Executive Director's Recommendation

Commission Meeting: May 4, 2017

PROJECT Building 58 Modifications and Addition Joint Base Myer – Henderson Hall, Fort McNair Southwest, Washington, DC	NCPC FILE NUMBER 7870
	NCPC MAP FILE NUMBER 24.50(38.00)44530
SUBMITTED BY United States Department of Defense Department of the Army	APPLICANT'S REQUEST Approval of comments on concept design
REVIEW AUTHORITY Federal Projects in the District per 40 U.S.C. § 8722(b)(1) and (d)	PROPOSED ACTION Approve comments on concept design
	ACTION ITEM TYPE Consent Calendar

Comments on Concept Design

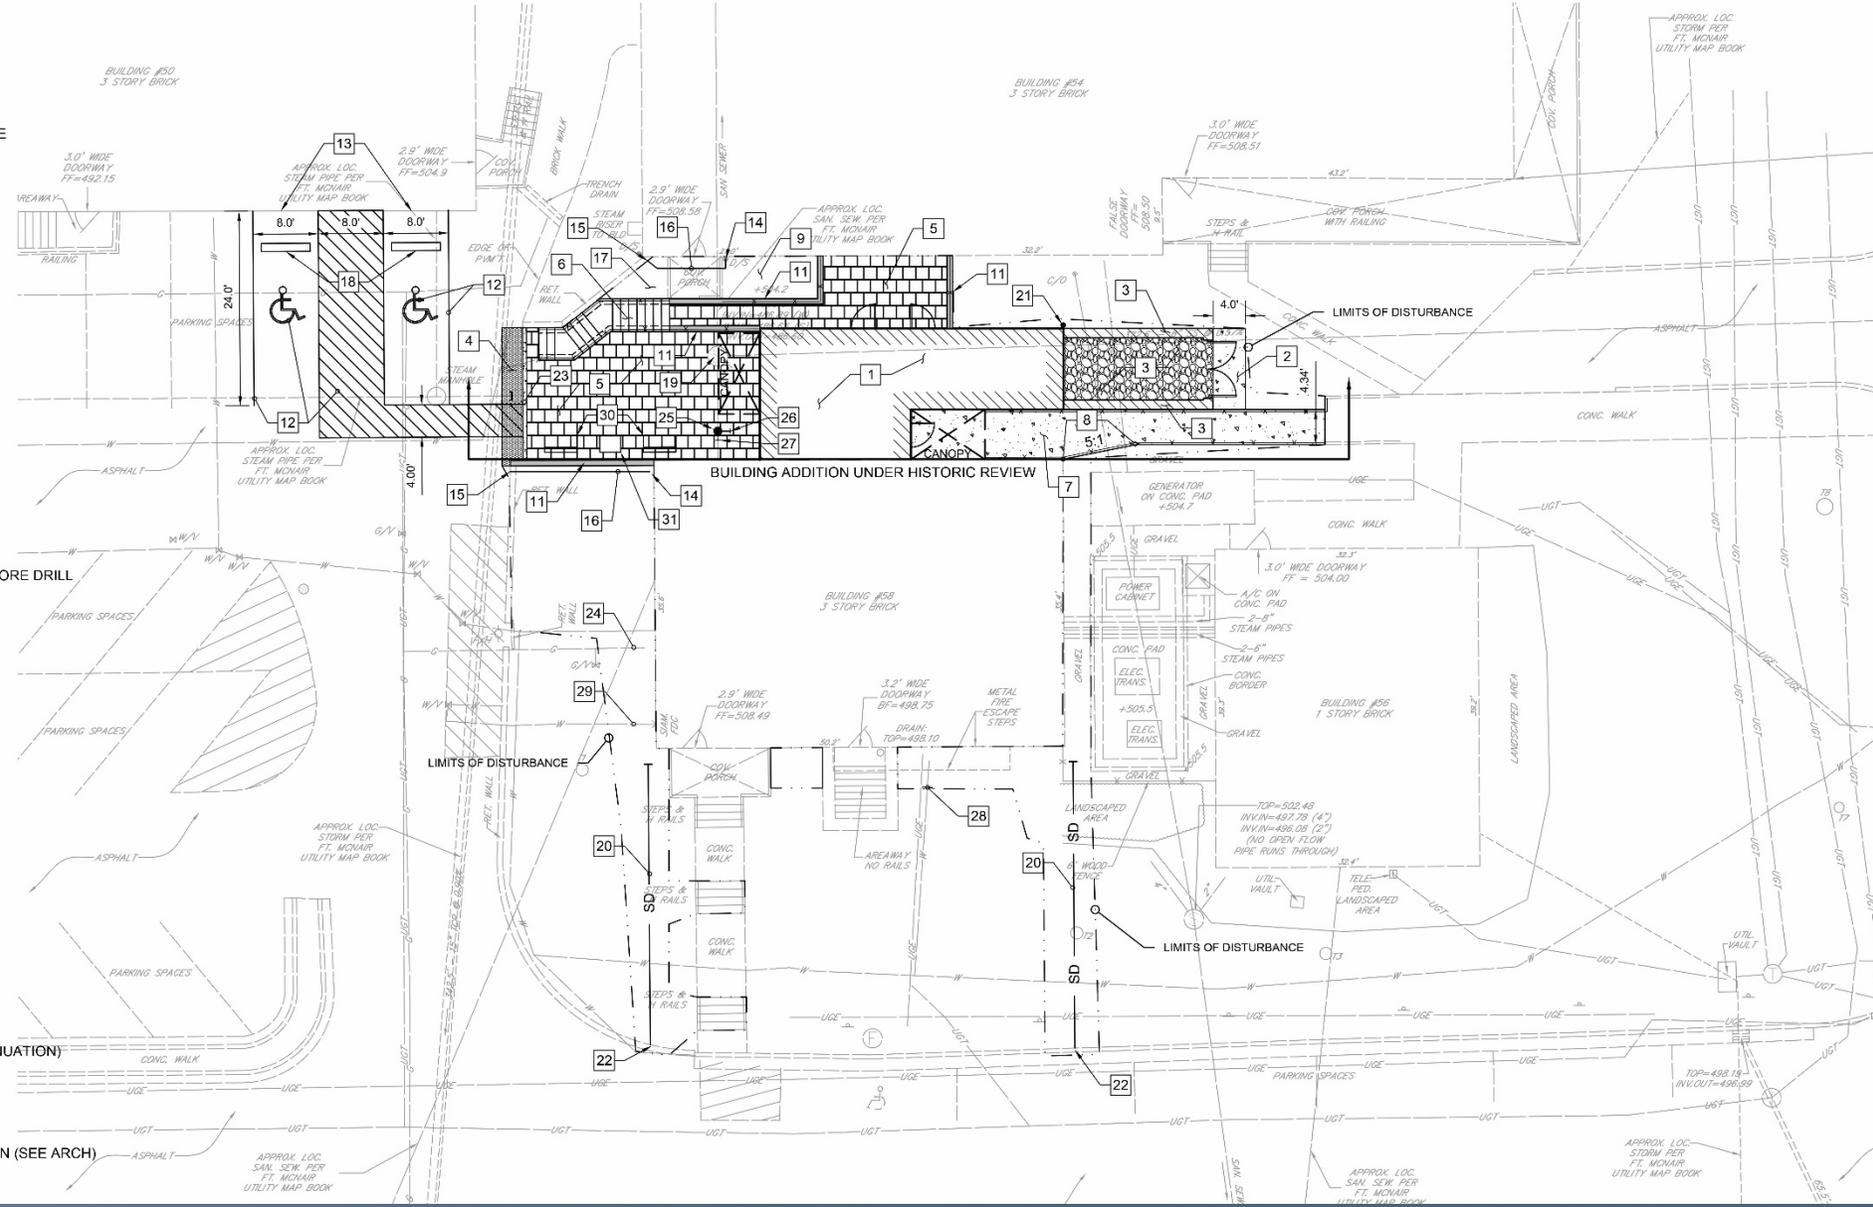
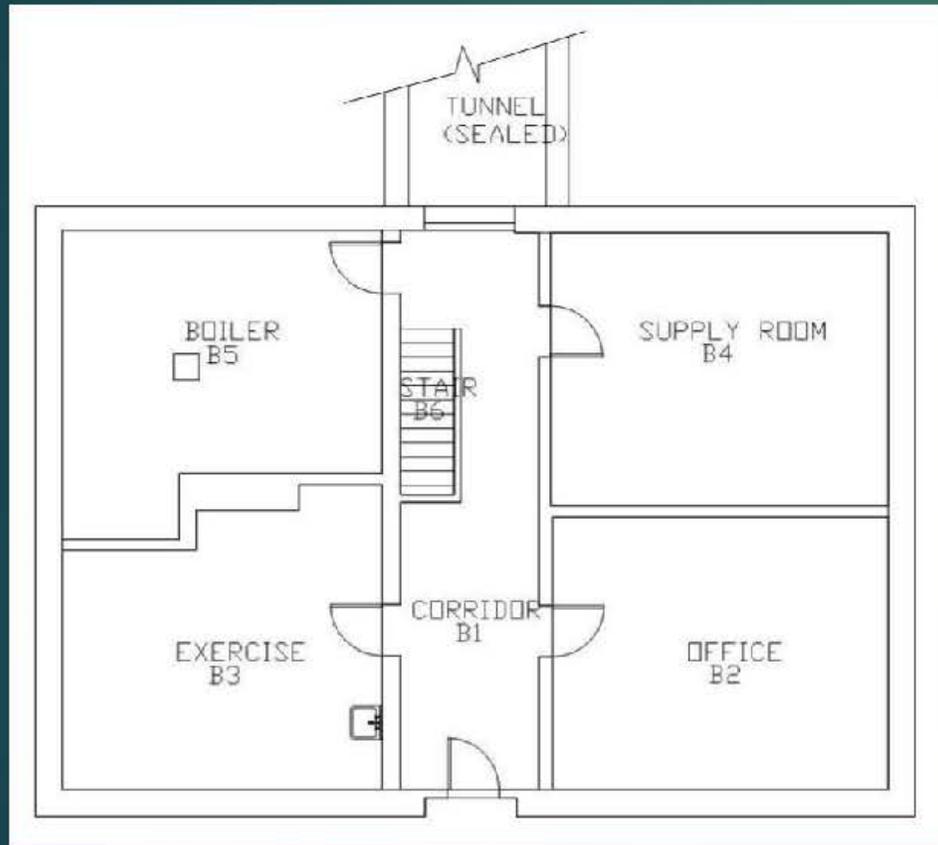
- Provide additional design details for the proposed entry plazas, exterior paving and site benches.
- Consider shade and views in relationship with the proposed benches at the grade level entry plaza.
- Integrate interpretive signage to highlight the proposed memorial element to be constructed from salvaged brick from the building demolition.
